Town of Hilton Head Island Regular Design Review Board Meeting

AGENDA

**Town of Hilton Head Island
Design Review Board
Minutes of the Tuesday, October 22, 2013 Meeting
1:15p.m – Benjamin M. Racusin Council Chambers**

PROTOTYPE SERIES
90 SL (C) - SDT
SHEET TITLE:
FRONT & REAR EXTERIOR ELEVATIONS

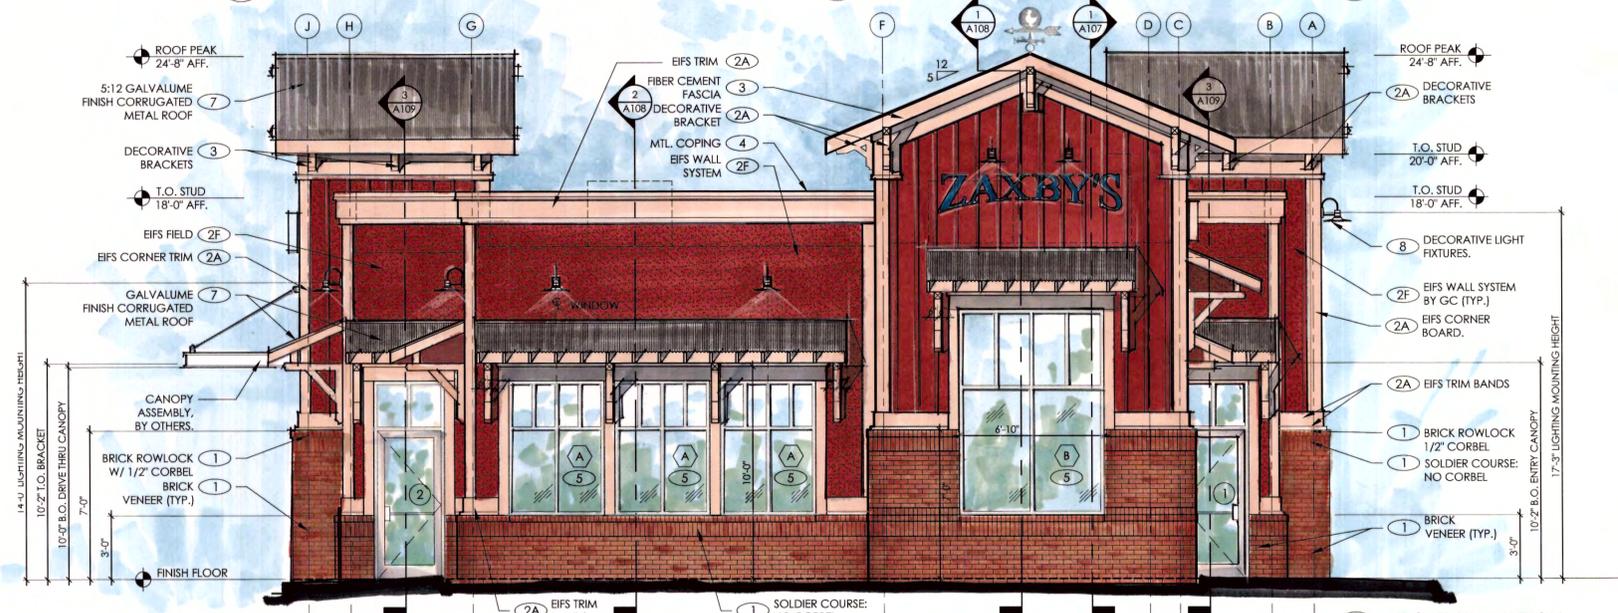
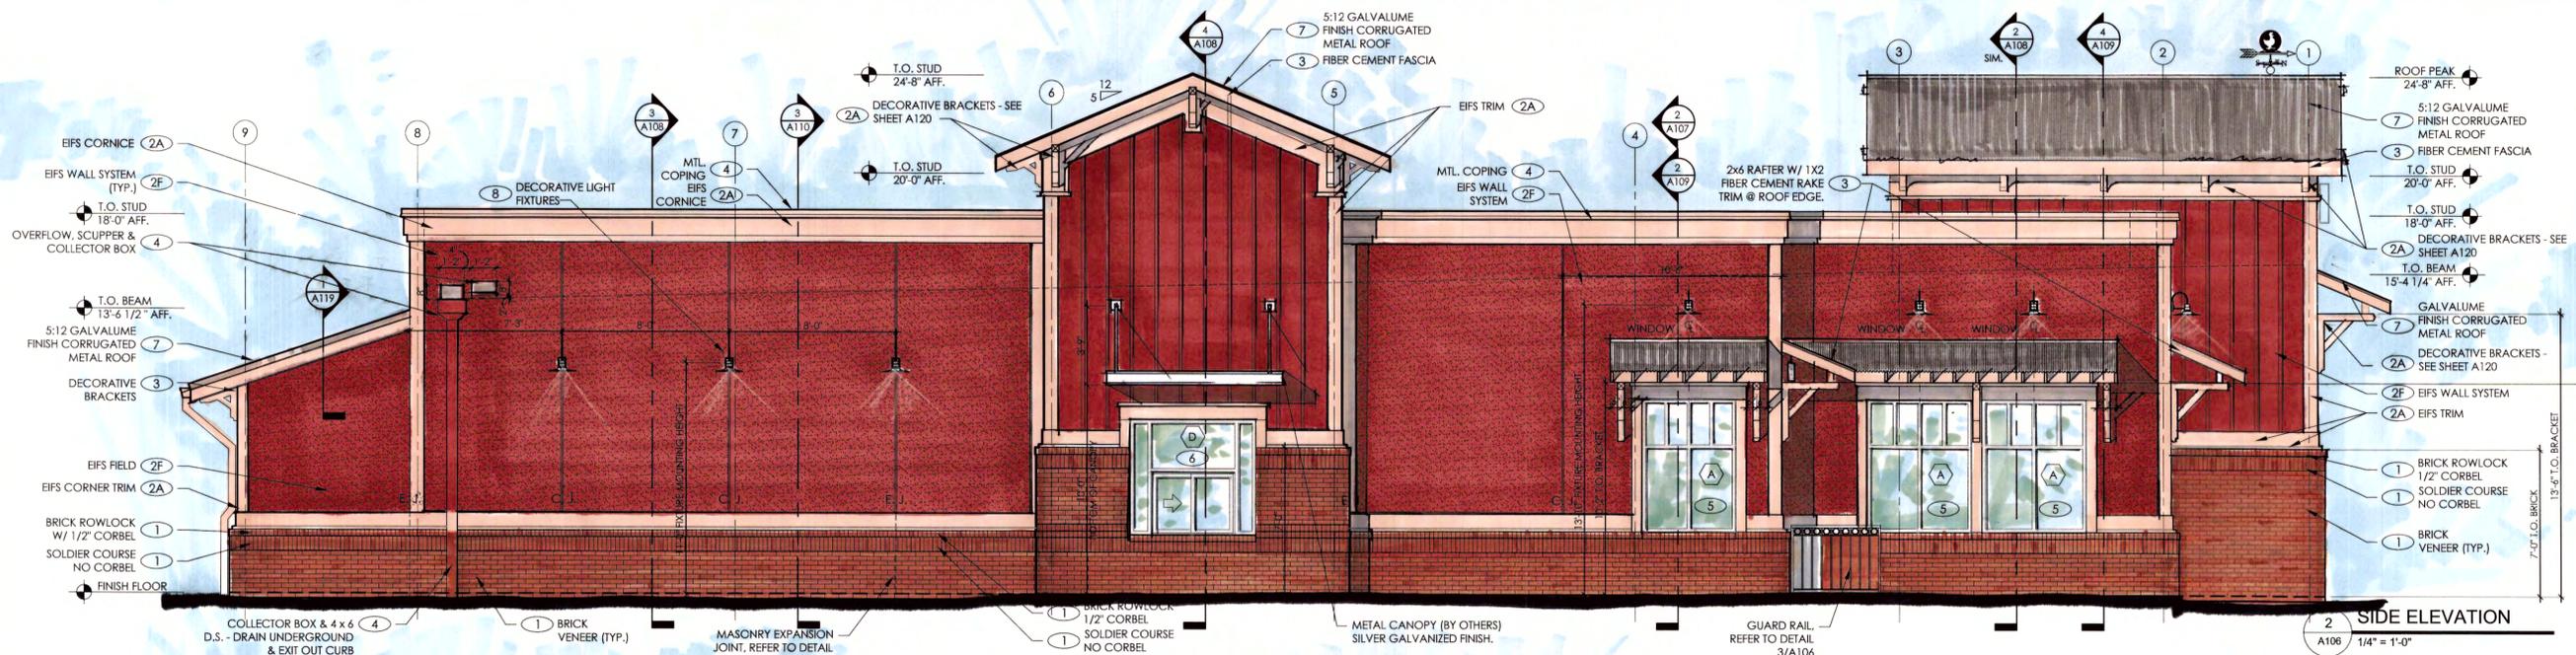
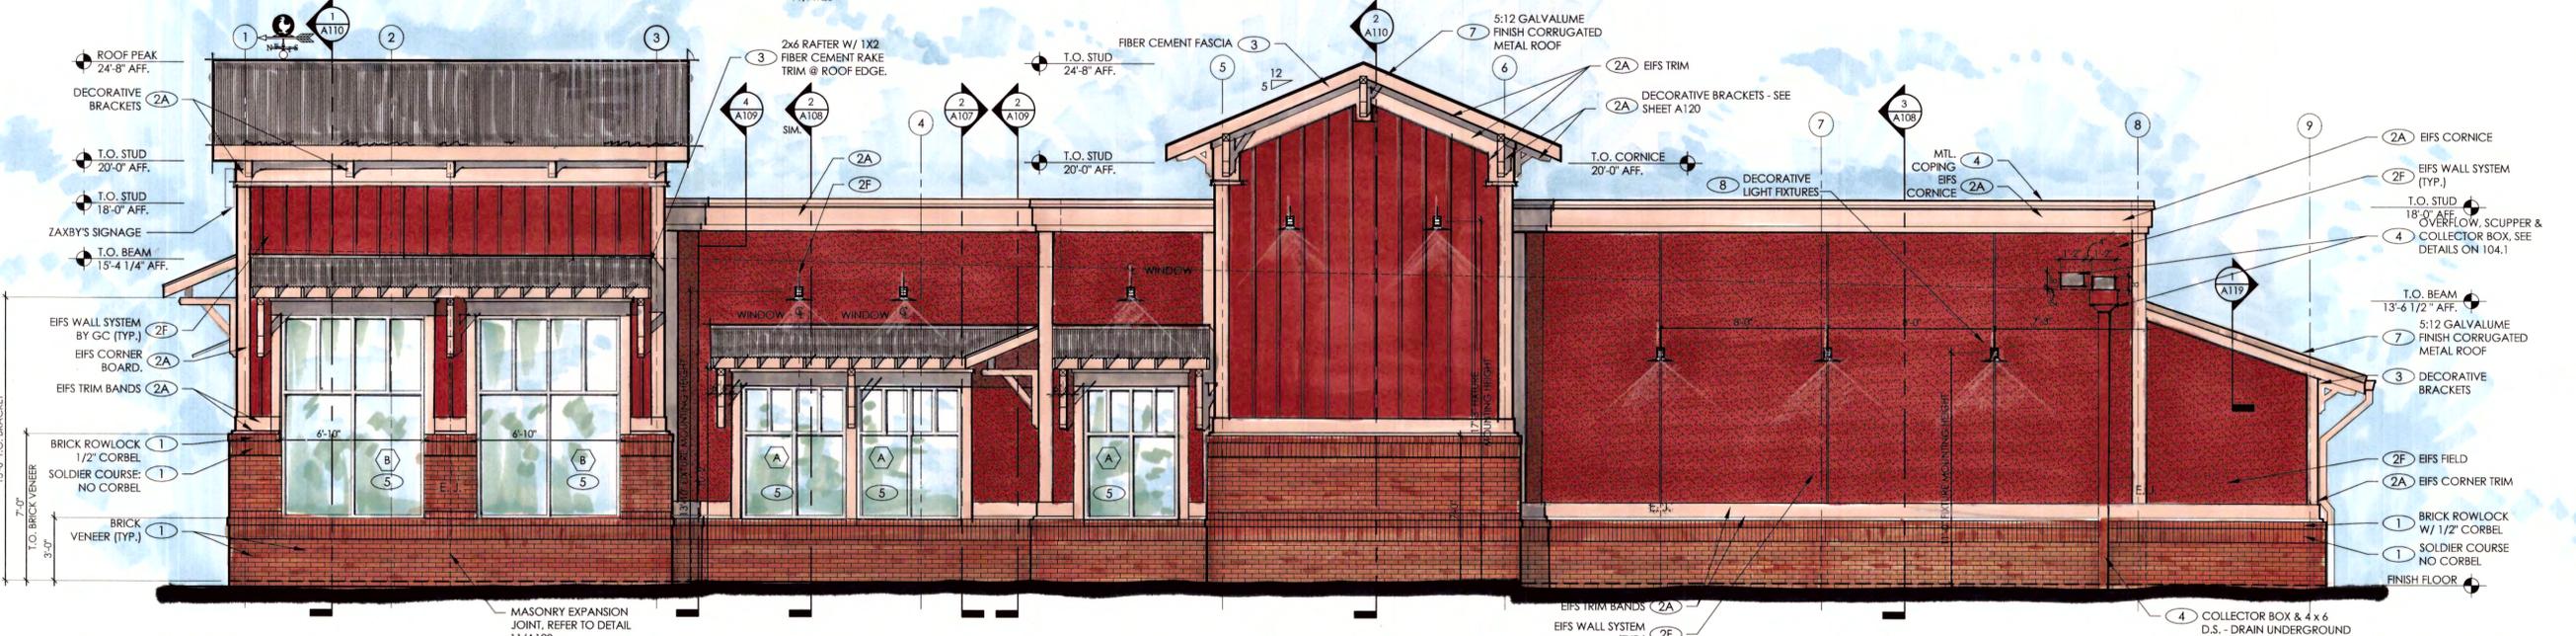
Design is appropriate for its use	<input checked="" type="checkbox"/>	<input type="checkbox"/>	<input type="checkbox"/>	
All facades are have equal design characteristics	<input checked="" type="checkbox"/>	<input type="checkbox"/>	<input type="checkbox"/>	
Avoids monotonous planes or unrelieved repetition	<input checked="" type="checkbox"/>	<input type="checkbox"/>	<input type="checkbox"/>	
Has a strong roof form with enough variety to provide visual interest	<input checked="" type="checkbox"/>	<input type="checkbox"/>	<input type="checkbox"/>	
Minimum roof pitch of 6/12	<input type="checkbox"/>	<input checked="" type="checkbox"/>	<input type="checkbox"/>	Roofs are "medium to low pitch" (5/12). Cornice treatment included along parapet walls.
Overhangs are sufficient for the façade height.	<input checked="" type="checkbox"/>	<input type="checkbox"/>	<input type="checkbox"/>	
Forms and details are sufficient to reduce the mass of the structure	<input checked="" type="checkbox"/>	<input type="checkbox"/>	<input type="checkbox"/>

Decorative lighting is limited and low wattage and adds to the visual character	<input checked="" type="checkbox"/>	<input type="checkbox"/>	<input type="checkbox"/>	Decorative galvanized goose-neck fixtures on building; no site lighting shown on conceptual submittal. Will require lighting plan and cut sheets of all fixtures for final submittal.
Accessory elements are design to coordinate with the primary structure	<input type="checkbox"/>	<input type="checkbox"/>	<input type="checkbox"/>	Details for dumpster/service area screen required for final submittal.

LANDSCAPE DESIGN- None included in conceptual submittal. Landscape plan with plant schedule required for final submittal.

Project required and received a special exception in May, 2013 for drive-thru. Applicant has not submitted for Pre-App or DPR and has not been reviewed by all staff reviewers. The site plan does not include provisions for storm drainage and proposes two additional curb cuts (one on Yacht Cove Drive and one on Marina Side Drive) that will require review/approval. Numerous signs shown on site plan and building façade signs will require review/approval as part of sign permit application.
